Responses to RWQCB Comments on the Revised Final Expanded Treatability Study Work Plan for OU-1 [October 16, 2003]

Revised Well Construction Diagrams Piping and Instrumentation Diagrams for Extraction/Injection Wells

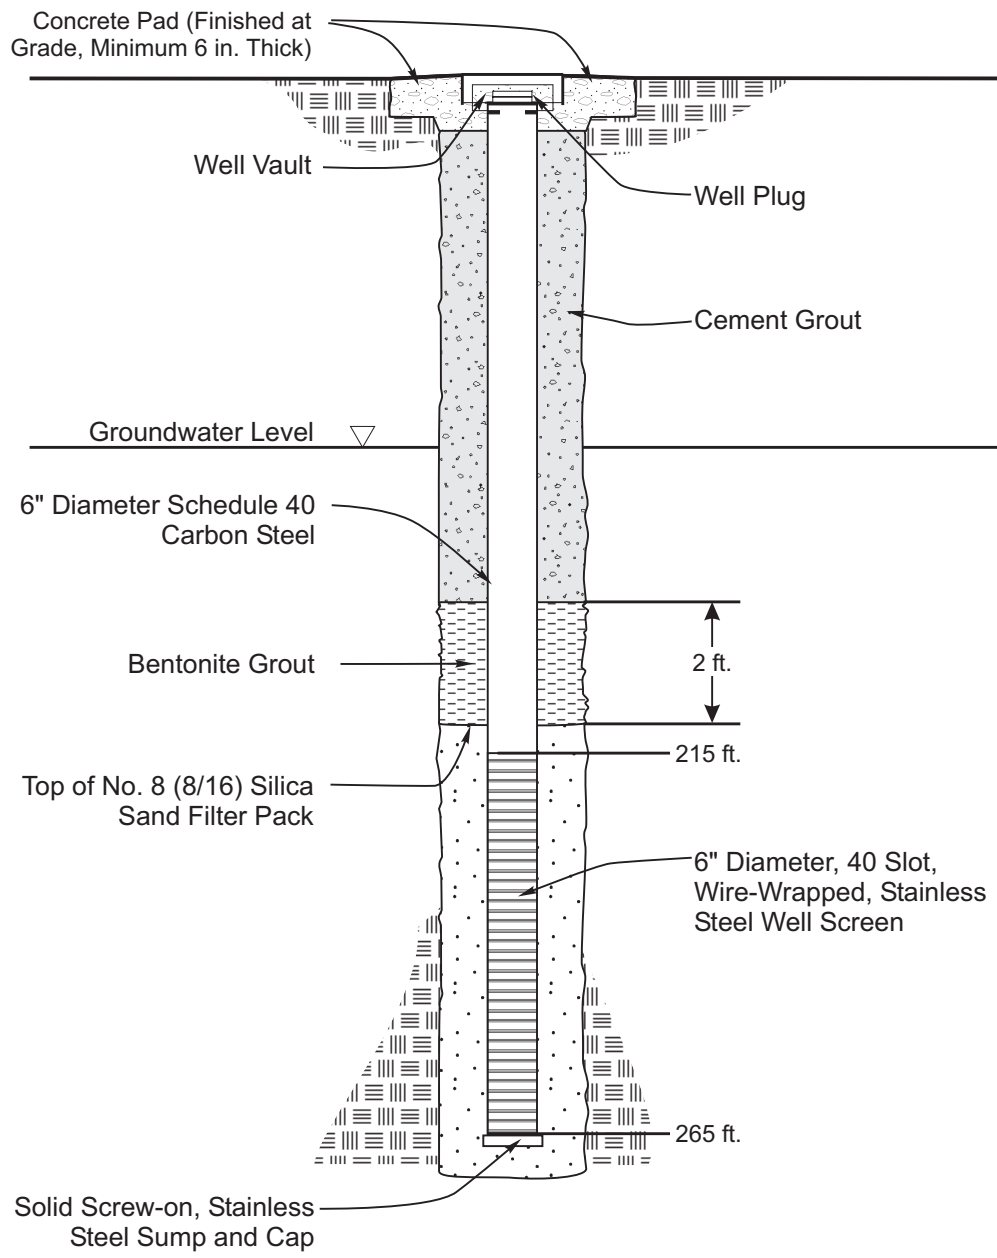
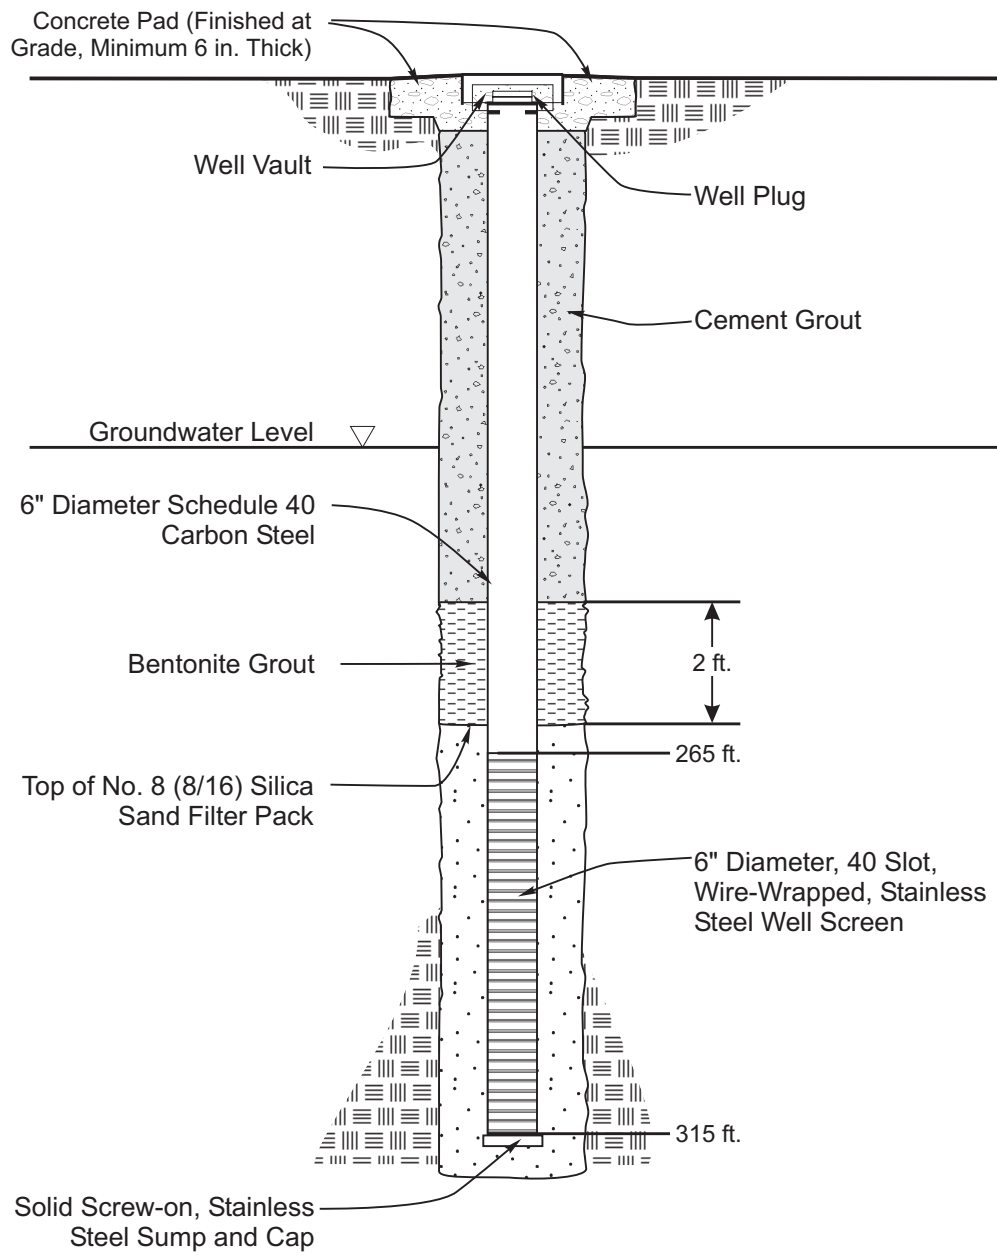
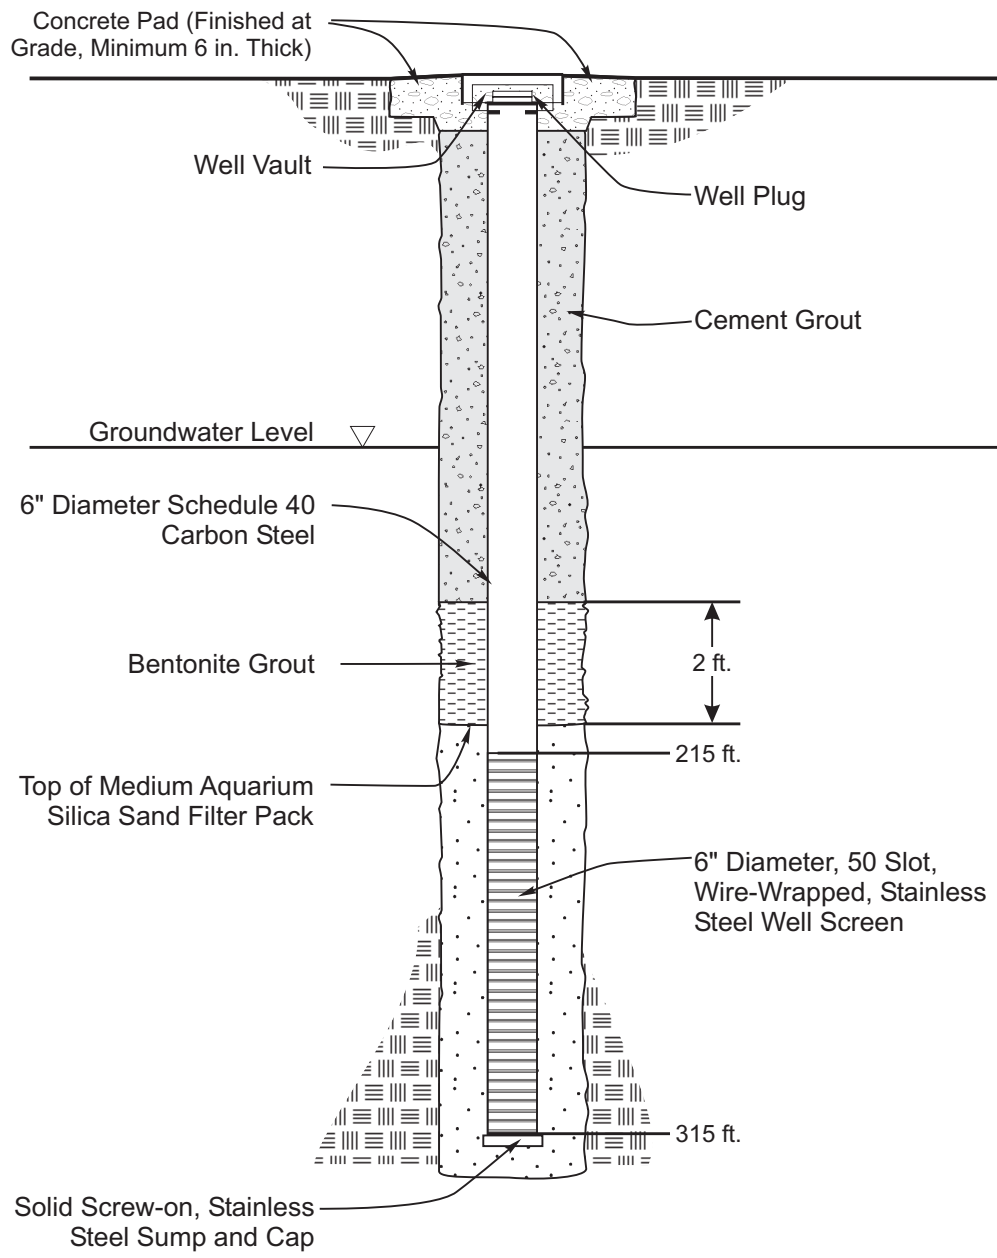
5	<p>Sections 4.2 and 4.3: The text specifies that the riser of the extraction and injection wells is to be made of Schedule 80 polyvinyl chloride (PVC) and the screen made of wire-wrapped stainless steel. However, the Tables 4-1 and 4-2 do not include a column for the stainless steel screen, and the column heading "Casing Depth" needs to be changed to Well Depth, and "Casing Material" needs to be changed to "Riser Material." To assure the long-term integrity and ability to resist chemical action in the saturated zone, Regional Board staff recommends the use of stainless steel risers in the submerged portions of the proposed extraction and injection wells. We recommend that you include a sounding tube and a gravel fill tube in the design of each extraction and injection well to facilitate measurement of groundwater levels in a non-turbulent environment. This may make it easier in the future to perform well maintenance after potential clogging of the screen intervals.</p>	<p>The revised well construction materials consist of a stainless steel screen and a carbon steel riser. The revised figures are provided in Attachment C.</p> <p>The need for sounding tubes as part of additional injection/ extraction well installations will be determined during implementation of the Phase I system.</p>
